Contract Change Order # 1

Project Name:	<u>Albany Street Southside Drainage Imp.</u>	Project Number:	<u>104283</u>
Project Location:	<u>Albany between 9th St. & County Line</u>	Date of Application:	<u>Tuesday, April 2, 2019</u>
Contractor:	<u>Cherokee Pride Construction</u>	Submitted By:	<u>Harlan Y.</u>

Project Name: VRWTP Caustic CIP Tank Replacement Project Number: 185436
Project Location: Verdigris River Water Treatment Plant Date of Application: Tuesday, April 2, 2019
Contractor: Young Contracting, LLC Submitted By: Mike Young

Project Name: Florence Street Bridge Repair over Creek Turnpike Project Number: ST1938
 Project Location: Florence Street - between Olive and Garnett Date of Application: Thursday, February 21, 2019
 Contractor: Cherokee Pride Construction Submitted By: Harlan Y.

FLORENCE STREET BRIDGE OVER CREEK TURNPIKE

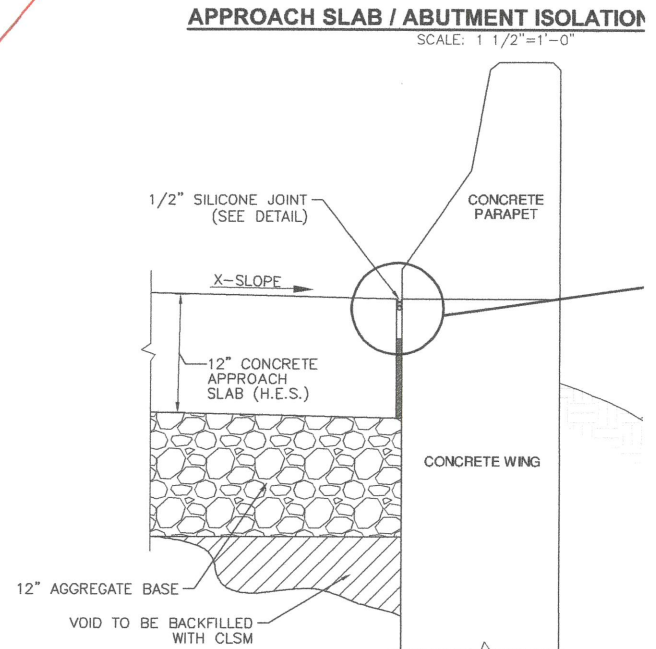
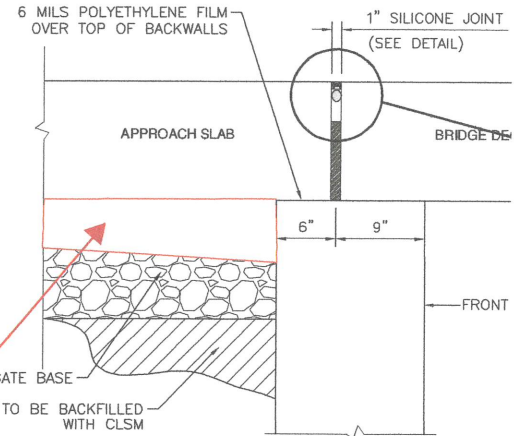
- During the excavation of the existing bridge approach concrete pavement over the existing known void cavity, it was observed that the abutment backfill on the west side of the bridge has settled. The attached detail shows the extents of the void cavity identified. Uretek - USA has reviewed the situation and provided a cost proposal to inject High Density Polyurethane into the void cavity from the surface of the existing pavement. This void fill is estimated at 1500lb of material and injection processes shall not exceed this amount. The contractor shall utilize this sub-contractor to perform this void fill operations and the below costs summarize the complete in place operation.

- 1) USA has reviewed the situation and provided a cost proposal to inject High Density Polyurethane into the void cavity from the surface of the existing pavement. This void fill is estimated at 1500lb of material and injection processes shall not exceed this amount. The contractor shall utilize this sub-contractor to perform this void fill operations and the below costs summarize the complete in place operation.

Put a 25' Tape under in this direction without stopping.
